Date: 2003-10-06

Engineering Change Order – Class I

MODIFICATION OF THE LQXC CRYO-ASSEMBLY

Figure 1. Comparison of the old (top) and new (bottom) configurations of the LQXC cryoassembly.

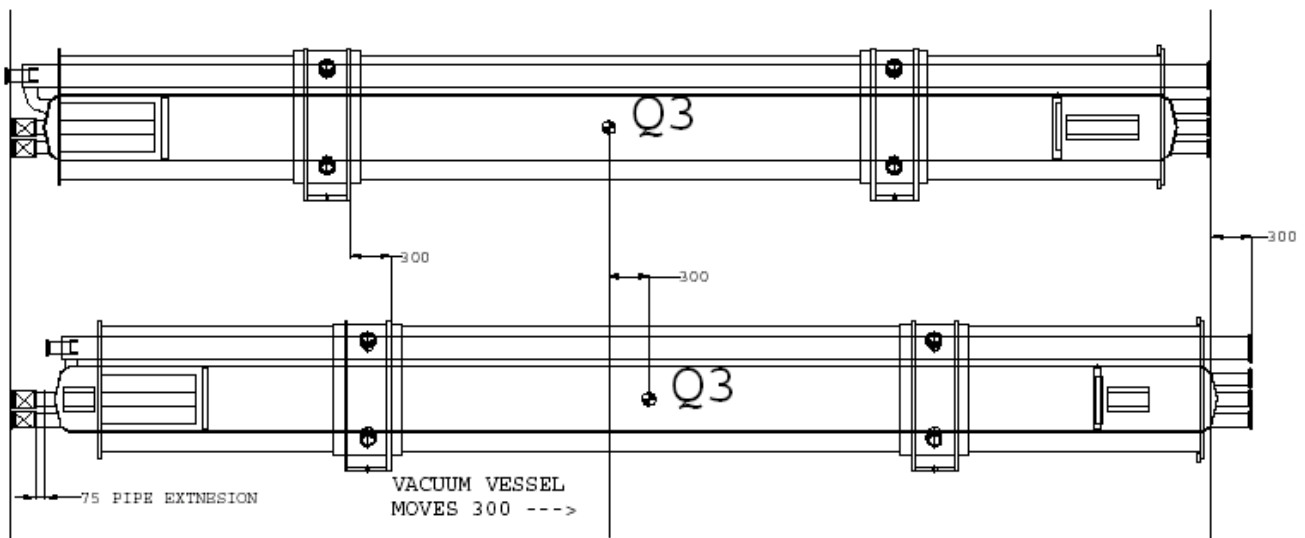
The position of the magnetic elements in the LQXC ("Q3") inner triplet cryo-assembly is shifted such that the a3-a4-b4 correction elements are placed on the non-IP side of Q3. Related to this change, the MQXA, MQSX and MCBXA magnetic elements are shifted by 300 mm towards the IP, and the relative positions of the interface locations of piping at the non-IP end of the LQXC assembly are shifted by 75 mm to allow more room for the assembly of the beam vacuum interconnect between the LQXC and the DFBX.

The non-linear correction coil package associated to the Q3 cryo-assembly (LQXC), which contains a3, a4 and b4 layers, must be moved from the IP end to the non-IP end of the assembly. This corrector package was previously part of the MQSXA magnet, but now will be a separate unit mounted by Fermilab to the non-IP end of the MCBXA corrector package that is on the non-IP end of Q3. This requires that the Q3 itself be moved towards the IP to make room between the DFBX and Q3 assembly for the a3-a4-b4 correctors. The IP end-dome of the Q3 cold mass assembly, which encloses the MQSX skew quadrupole corrector, will be unchanged in length, while the non-IP end dome will be extended in length by 225 mm to accommodate the a3-a4-b4 corrector package. The pipes connecting the Q3 to the DFBX will be lengthened by 75 mm to provide additional space for assembling the cold bore interconnect. This results in a shift by 300 mm towards the IP of the magnetic centers of the MQXA, MCBXA and MQSX magnets. The cryostat is also moved 300 mm towards the IP. This increases the distance between the DFBX and the Q3 cryostat, such that a standard 810 mm length vacuum bellows can be used.

In the current layout, the a3-a4-b4 corrector package is at a location where the beta functions are equal in the two planes, in which case the scheme for correcting the effect of quadrupole errors on both beams is ineffective. At the new location, the beta functions are substantially different, restoring the effectiveness of the correction system.

Advantage is taken of the necessity to modify the Q3 configuration to provide an additional 75 mm to ease the assembly of the beam vacuum interconnect, and to allow the use of a bellows assembly for the insulating vacuum that is of a standard length used elsewhere in the LHC.

The old and new locations of the magnetic elements in the LQXC cryo-assembly are summarized in Table I. The old and new configurations of the LQXC cryo-assembly are shown in Figure 1.

Component	IP to Mag. Center (old)	IP to Mag. Center (new)	
MQSXA	46.91 m	46.61 m	
MQXA (Q3)	50.45 m	50.15 m	
MCBXA	54.10 m	53.80 m	
b3-b6 correctors	54.30 m	54.00 m	[a]
a3-a4-b4 correctors	46.67 m	~ 54.5 m	[b]
